Rezoning Transportation Analysis

Petition Number: 2023-088

Date	Description
07-26-23	First Review (PM)
08-24-23	Second Review (NK)
9-27-23	Third Review (NK)

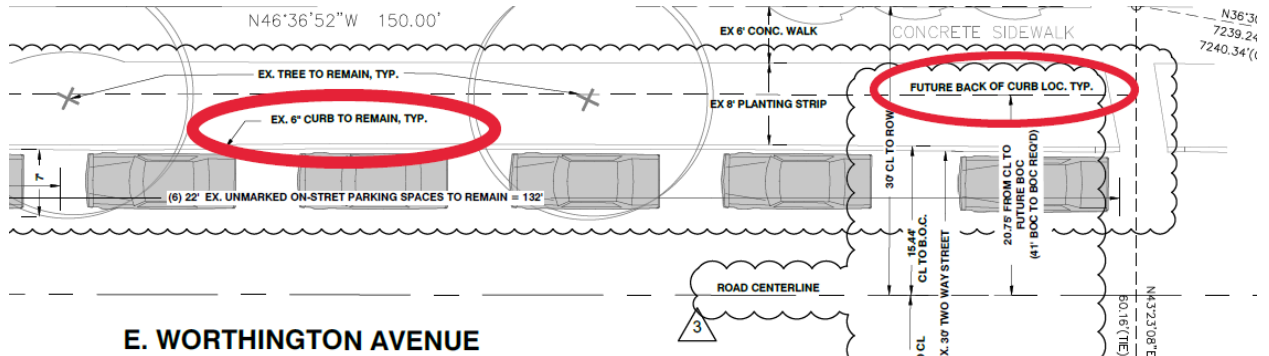
1. ~~Outstanding Issue 7/26/23~~ Curblines:

- a. ~~Cleveland Avenue: The future location of curb and gutter is to be located at 20.5ft per CLDM U-05 series for local commercial wide street typical section.~~
- b. ~~Worthington Avenue: The future location of curb and gutter is to be located at 20.5ft per CLDM U-05 series for local commercial wide street typical section.~~

Label and dimension the future back of curb location from the centerline for each road on the site plan.

~~Clarifying Comment 8/24/23: Cleveland and Worthington Avenues are both shown as 30' wide streets on current site plans. These streets must be at least 41' wide from back of curb to~~

back of curb per CLDM U-05. Additionally, each road must label and dimension future back of curb location to the centerline.

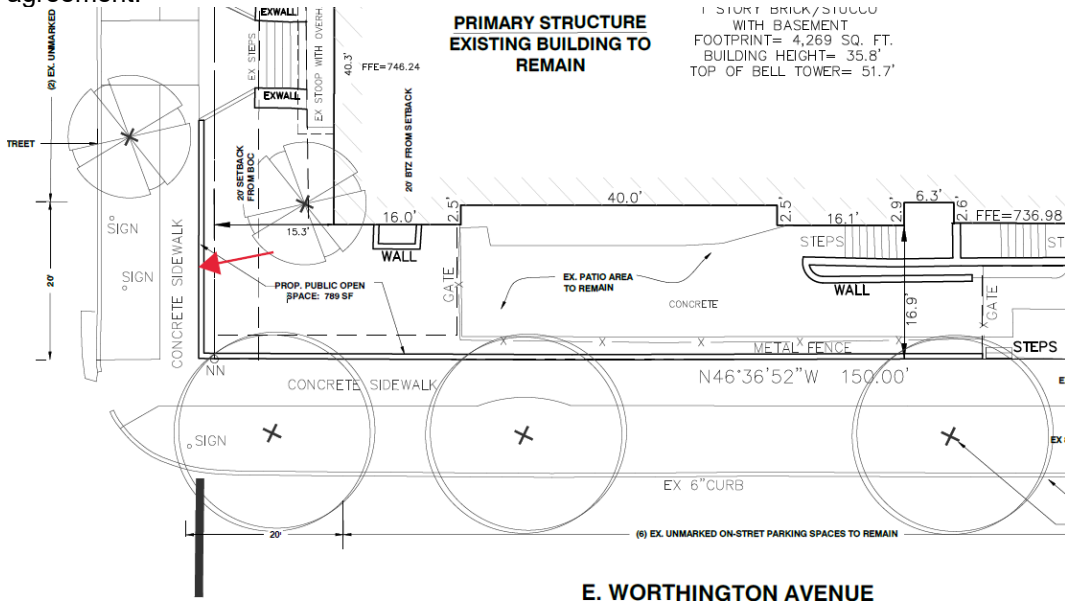
4. ~~**Outstanding Issue 7/26/23:** Revise site plan to show the centerline on each public street. Dimension the right-of-way and the back of curb from the centerline.~~

5. ~~Revise site plan to clarify if the wall is proposed or existing. If the existing wall is being replaced, CDOT would prefer that it be placed outside of the right-of-way, otherwise will need an encroachment agreement.~~
